COUNCIL ASSESSMENT REPORT

Panel Reference	PPSSCC-130
DA Number	DA 84/2021/JP
LGA	The Hill Shire Council
Proposed Development	Medical Centre and Child Care Facility for 84 Children
Street Address	27 Hynds Road, Box Hill (Proposed Lot 1 in a resubdivision of Lot 85 DP 11104)
Applicant/Owner	Baini Design/Javian Development Pty Ltd
Consultant/s	Baini Design Think Planners Rodney Stevens Acoustics Australian Consulting Engineers Stanbury Traffic Planning RGM Property Surveys Ideal Geotech Vista Access Architects AA Power Engineering Advanced Arborist Reporting Outside Design Group (Landscape Architect) QPC & C Pty Ltd (Registered Quantity Surveyor)
Date of DA lodgement	21 July 2020
Number of Submissions	Nil
Recommendation	Refusal
Regional Development Criteria (Schedule 7 of the SEPP (State and Regional Development) 2011	Private infrastructure and community facilities over CIV \$5 million (child care centre and health services facility) CIV: \$5,050,587

submissions	
Report prepared by	Harrison Depczynski, Senior Town Planner
Report date	12 May 2021 (Electronic)

1 Basement 2 (Lower)
1 : 100

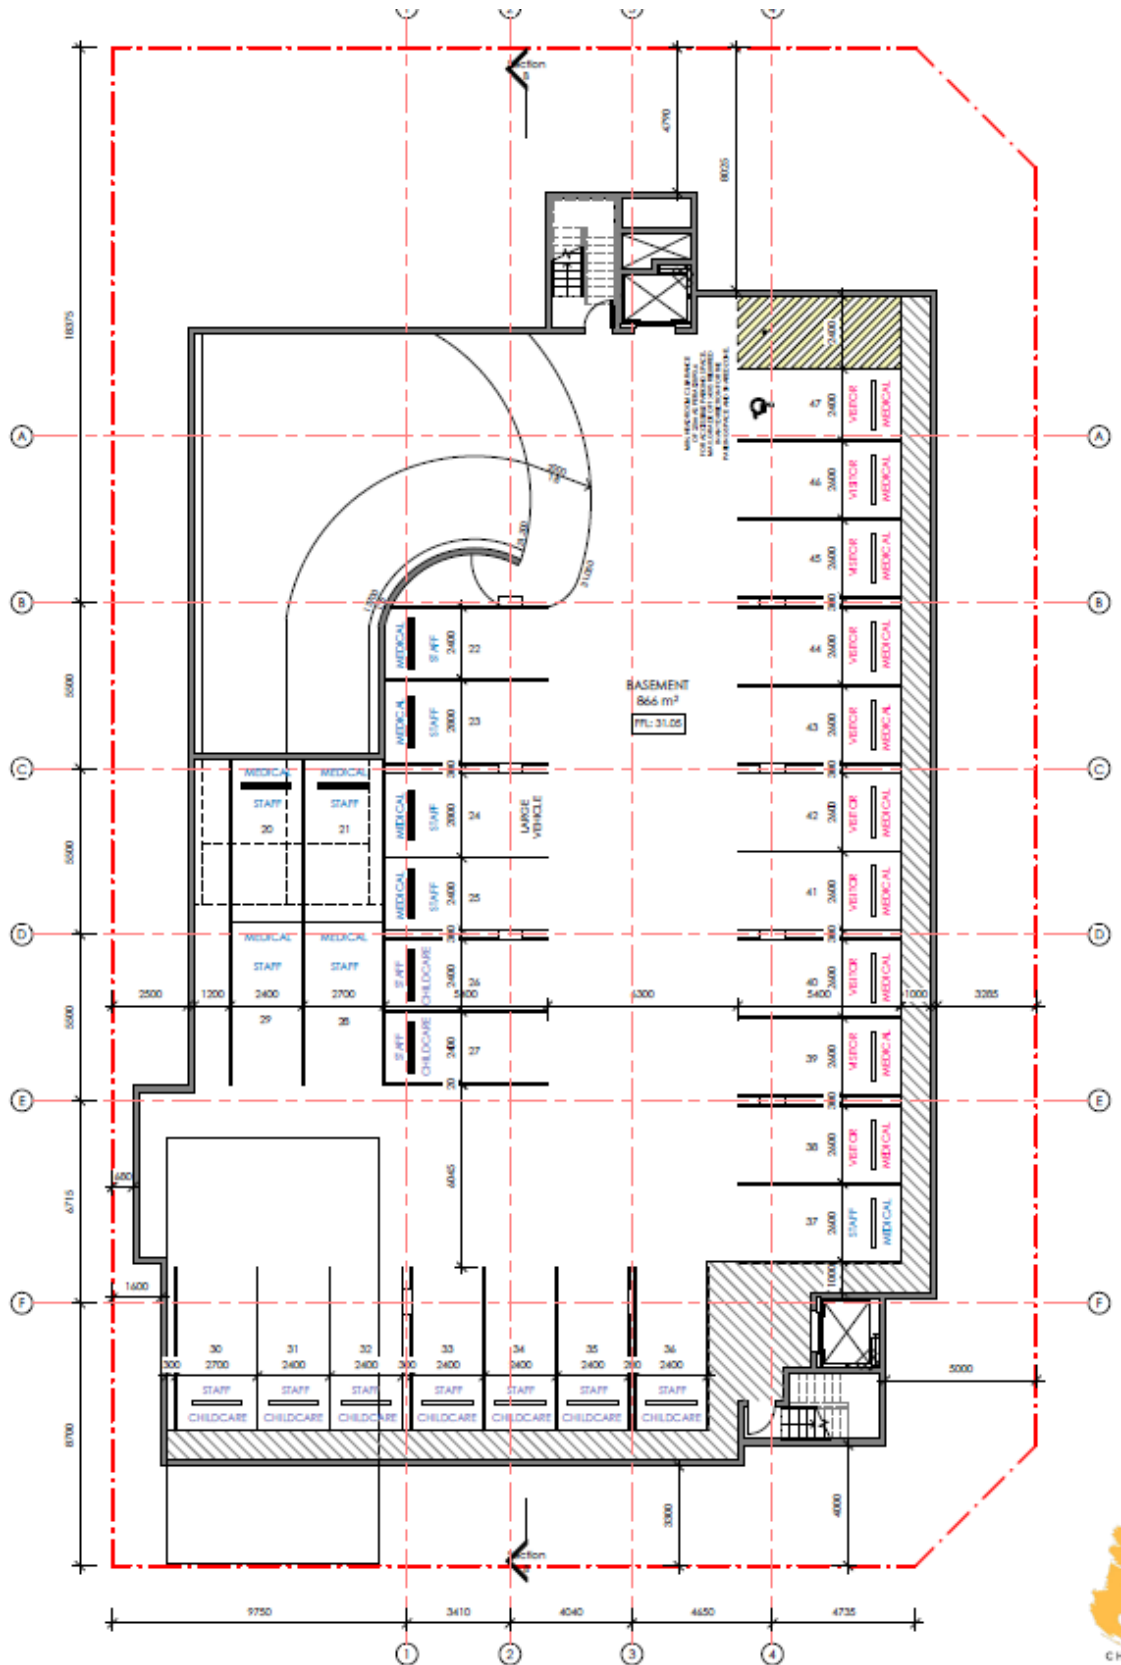
- Swept path plan shall be provided to demonstrate how visitor spot 13 can negate the space without traversing over the pedestrian walk way.
- A dedicated turning bay is to be provided on basement 2 at the termination of the aisle (e.g. in location of car space no. 30).

1 Driveway Section
1:100

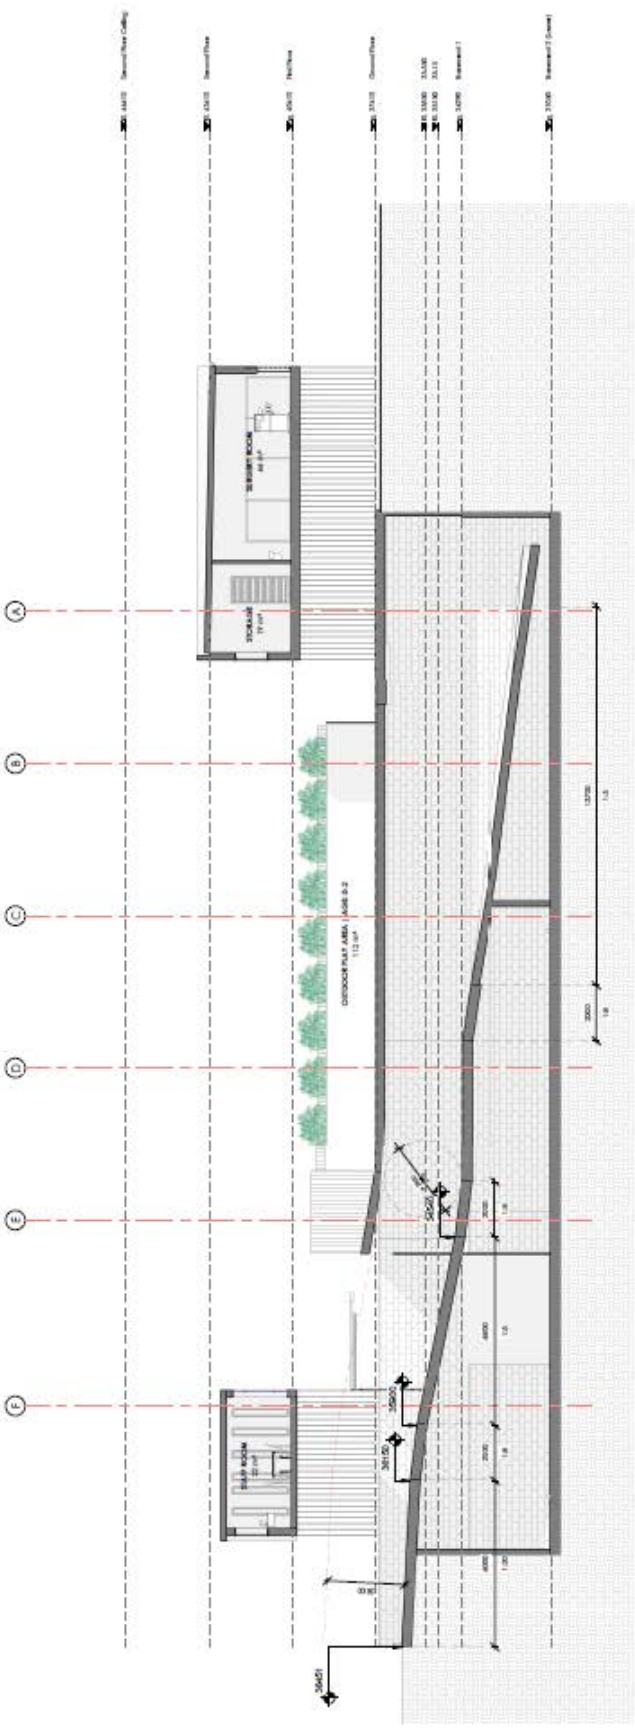
- The basement retaining wall meeting the front boundary of Zaniah Street has no T.O.W levels provided. The driveway section suggests a wall approximately 900mm high meeting the boundary. This wall is to be detailed, and lowered to follow N.G.L. Furthermore, a wall is indicated on the 3D imagery, on the opposite side of the driveway adjacent the path, which is not indicated or detailed on plans. Whether or not these walls will affect sight lines for traffic are not clear. All indications of this wall suggest an unfinished concrete block wall. The material of the basement retaining walls, and other high walls indicated with this hatch facing Hynds Road and Nova Street are to be clarified and detailed.
